Technical Bulletin

Servicing Meritor TN/TP Series Trailer Axles Equipped with 12.25" x 7.50" Brakes

ABS Block Location Change

TP-19110
Issued 08-19
(16579)

Figure 1

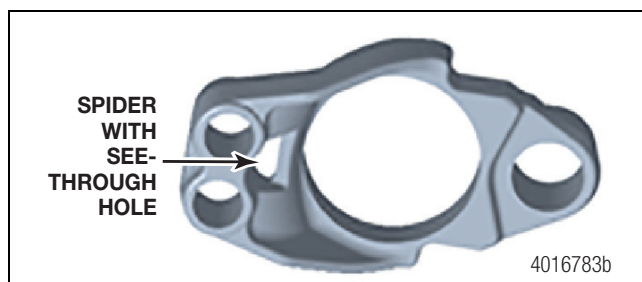
Effective August 1st 2019, ABS blocks are now located at the same position on both TN and TP series trailer axles equipped with 12.25" x 7.50" brakes. Modifications were made to the brake spider and return spring to accommodate this change.

If the spider on the axle has a see-through hole (Figure 1) **AND** the ABS block is in line with it (Figure 2), use the post-August 1, 2019 return spring to service the axle. All others use the pre-August 1, 2019 return spring. Figure 3.

Figure 3

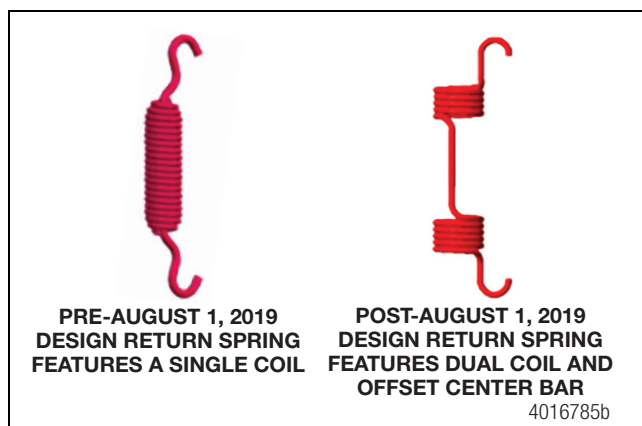
Meritor aftermarket kits now include the pre-August 1, 2019 design return spring that features a single coil, as well as a post-August 1, 2019 design return spring that features a dual coil with an offset center bar. To determine which spring to use, check the spider and ABS block for the following:

NOTE: The post-August 1, 2019 return spring must be installed with the offset center bar positioned outboard of the axle. This position is necessary to prevent the spring from contacting the ABS sensor.
